Agenda Item # 6

BOA-002778-2023

- A Height Variance request to allow a structure taller than 45-feet in a B-3, Community Business Suburban District

APPLICATION NUMBER <u>6567</u> DATE <u>January 8, 2024</u>	 NTS
APPLICANT <u>Eduardo Robinson, DI Hotels Sun, LLC</u>	
REQUEST <u>Height Variance</u>

SITE PLAN

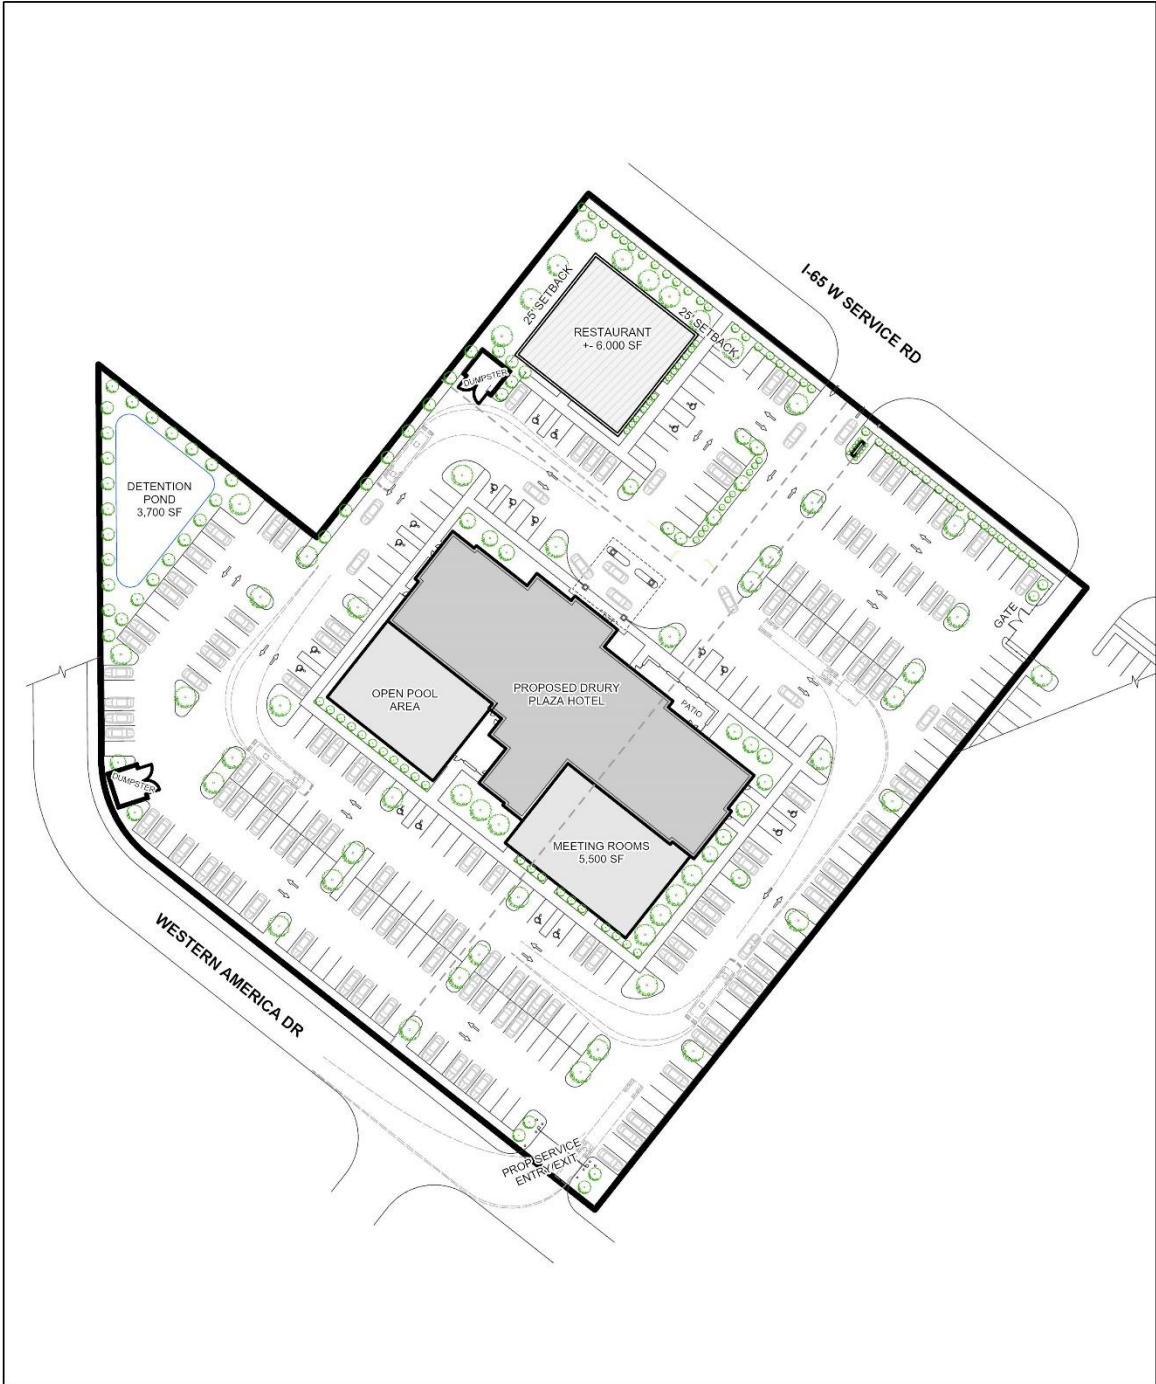
The proposed site plan submitted depicts a trash enclosure near the property line along Western America Drive. It should be noted that any dumpsters and enclosures must be relocated outside of any required setbacks, if approved.

The applicant states that the proposed hotel will have a total of 186 rooms, and the proposed restaurant will be 6,000 square feet; therefore, a total of 113 parking spaces are required. However, there is also 5,500 square feet of "meeting rooms" depicted on the site plan, which requires an additional 14 parking spaces, for a total of 127 required parking spaces. The site plan depicts a total of 294 parking spaces. At the time of permitting, a compliant photometric site plan will be required. Furthermore, the 167 parking spaces exceeding the minimum required amount will be required to be paved with an Alternative Paving Surface. Also, all parking spaces are required to have either curbing or bumper stops.

The subject site has an existing shared curb cut with a hotel to the East of the site. The proposed site plan depicts a gate and fence at this curb cut restricting access to the property. It appears that the proposed gate is less than 12-feet wide, and is therefore insufficient to allow vehicular traffic. If the proposed gate is for pedestrian access, it should be labeled as a pedestrian gate; or if the proposed gate is to serve vehicles, it should be revised to be a minimum of 24-feet wide to allow two-way traffic and insure that sufficient queuing spaces are available.

- 1) Revise the site plan to relocate the trash enclosure outside of all required setbacks;
- 2) Revise the site plan to correct the parking calculations to include the 5,500 square feet of meeting rooms;
- 3) Revise the site plan to depict curbing and/or bumper stops for all parking spaces;
- 4) Either revise the site plan to state the proposed gate will be for pedestrian access only, or make the gate a minimum of 24-feet wide with adequate queuing spaces;
- 5) Placement of a note on the site plan stating that each business (hotel and restaurant) is limited to a total of three (3) signs with no more than one (1) freestanding sign; and
- 6) Either completion of a one (1) lot Subdivision, or recording of an easement in Probate Court to allowed shared parking between the lots prior to the approval of any building permits for the proposed development.
